Access Compliance Report

Public Rights-of-Way

(Pedestrian Signals)

Intersection ID: N/A	Main Street:	Cross Street: N/A	Location: N/A
ADA ID: E2C3AEFE0B36	Signal Type: Two Push Buttons-Non APS	Overall Compliance: No	Severity Score: BTN 1:N/A BTN 2: N/A No BTN: N/A
Codes/Mitigation Info/Possible Solution		Field Measurements/Component Compliance

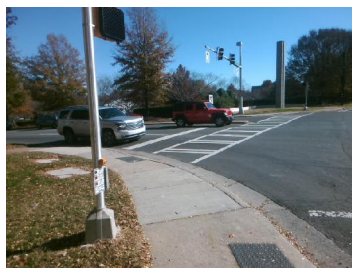
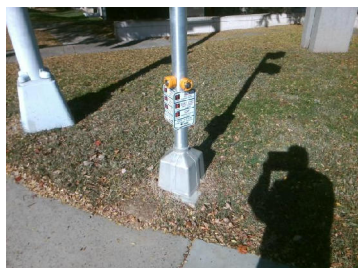
Possible Solutions: Replace Signal Push Button With APS Button on New Post. Remove & Relocate Sign.

PROW/ADA: TMUTCD 4e.08, R406.2, R404.7.3
